WASHINGTON METROPOLITAN AREA TRANSIT AUTHORITY
CARMEN TURNER FACILITY HOMT REHABILITATION GUIDE

XCELSIOR DIESEL-ELECTRIC 40 FT. TRANSIT BUS

Cummins ISL9 (CM2350 L101) Air Compressor Stainless
Steel Coolant Hose Upgrade

WMATA BUS FLEET ENGINEERING
EMI No.: BUSV-BMNT-EMI-24-PT-01-00
Page 1 of 7

Figure 3: Compressor Fitting Removed

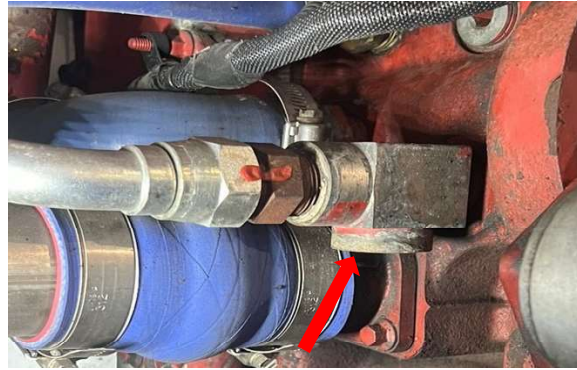
7.1 If present, remove the factory coolant tube and factory fittings from the air compressor cylinder head (Figure 3) and water outlet tee on the right front side of the engine block (intake side, Figure 4)

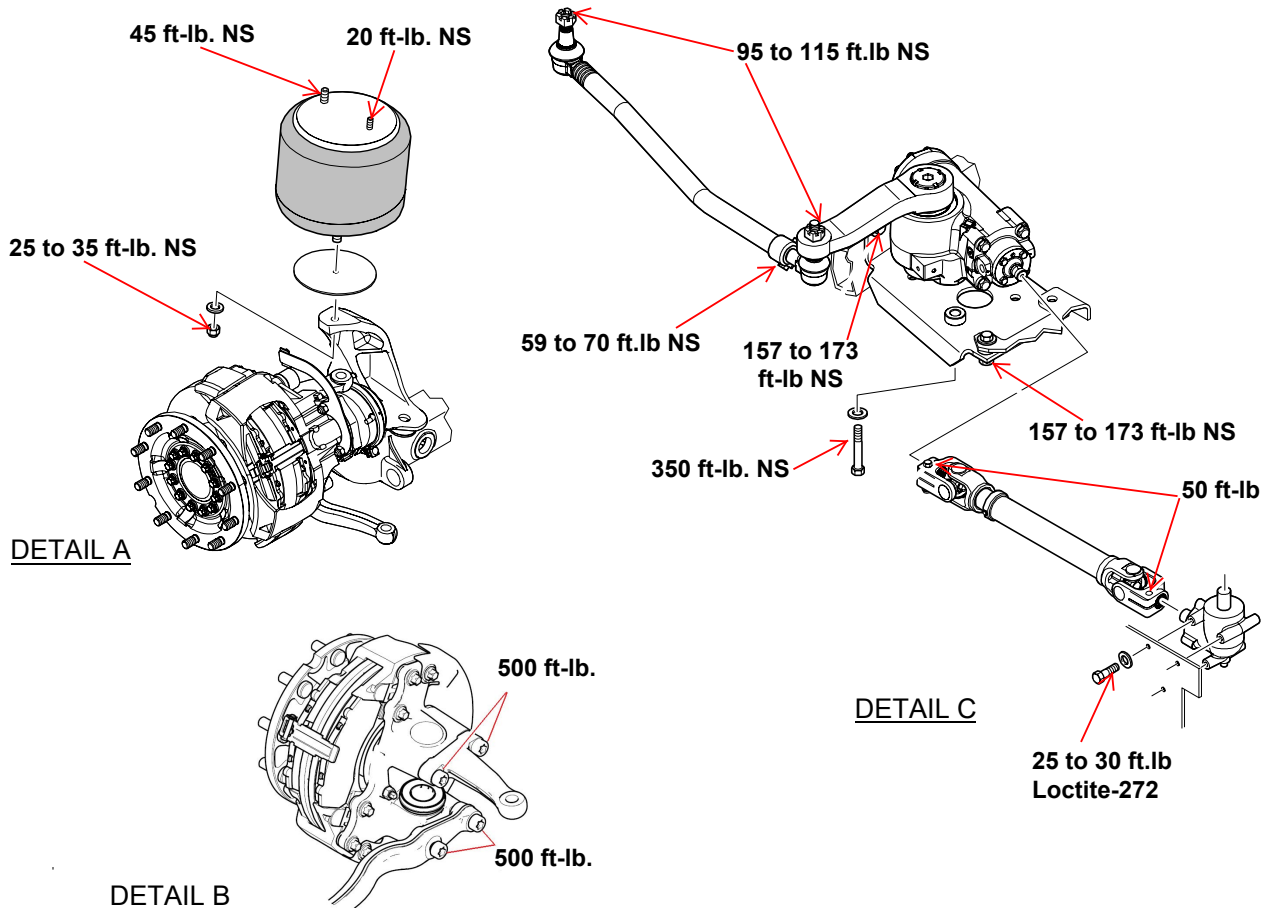
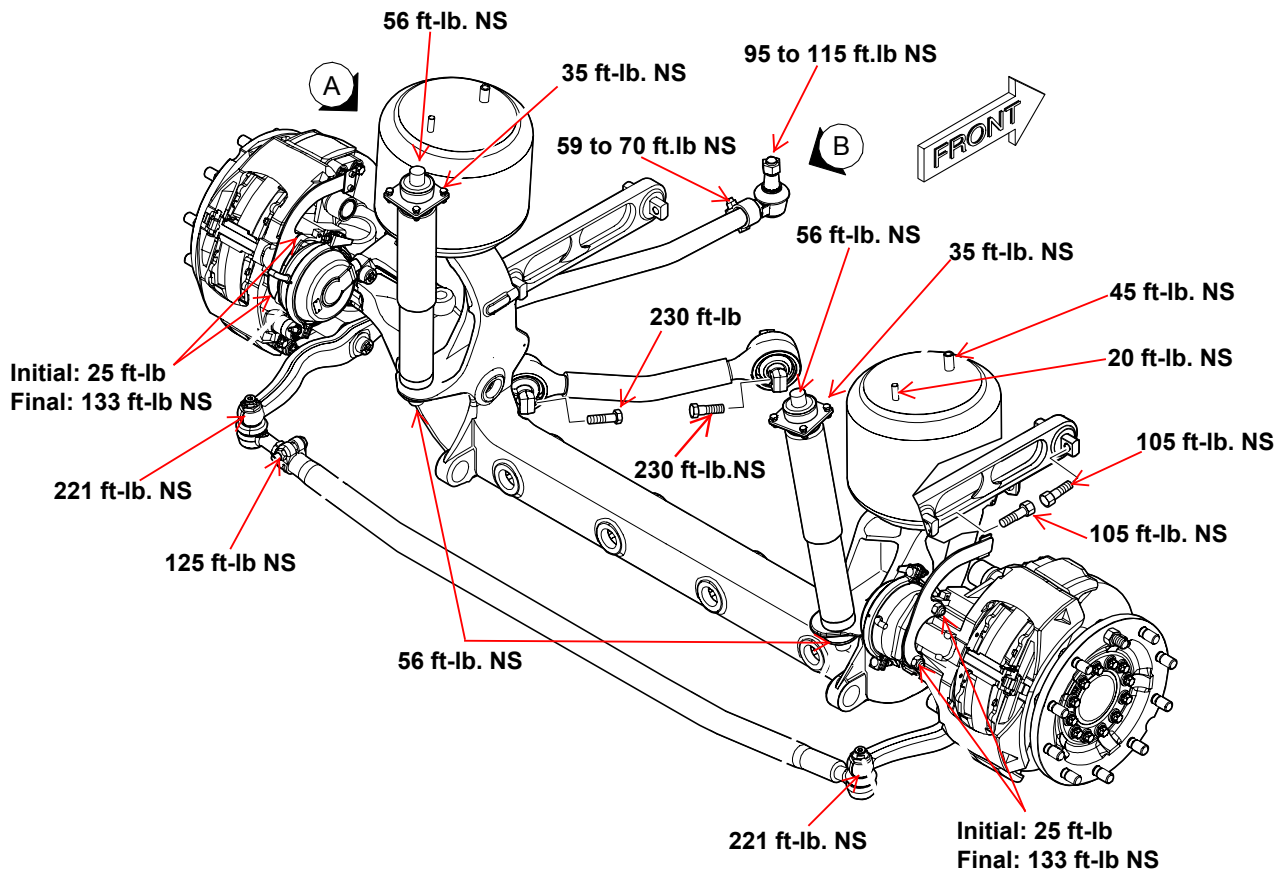
The New Flyer Xcelsior bus fleets come equipped with Knorr-Bremse calipers. However, starting with **Fleets 56 (7300-7355) and 57 (7356-7409)**, the Knorr-Bremse calipers will be replaced with **Meritor EX225 calipers** on all axles during the buses' midlife overhaul/ rehabilitation.

These Meritor calipers are a direct replacement for the Knorr-Bremse calipers. They have been adapted to fit onto the wheel ends of the MAN VOK-07-F steer axle and the MAN HY-1350-F rear axle. **Note: They are not interchangeable with the Meritor calipers used on the Orion or NABI fleets.**

- **Caliper (or Carrier) Mounting Bolts Torque Value:**
 - **Front & Rear Axle Caliper Bolts: 288 ft-lb (same as Knorr-Bremse)**
- **Manual Adjustment Procedure.** After brake pad installation, use a 10 mm box-end wrench or socket to tighten the adjusting nut (clockwise) until the pads contact the rotor. Then back off the nut (counterclockwise) **½ turn. Caution: Do not exceed 30 ft-lb when turning the adjusting nut in either direction.** Apply the brakes multiple times before measuring the running clearance.
 - **Note:** There is no "clicking" when backing off the adjusting nut on this caliper, but there should be resistance.
- **Brake Temperature Chart.** When measuring brake temperatures, use the MAN-ZF Axle Bus Fleets (Estimated) Rotor Temperatures Chart (See link).
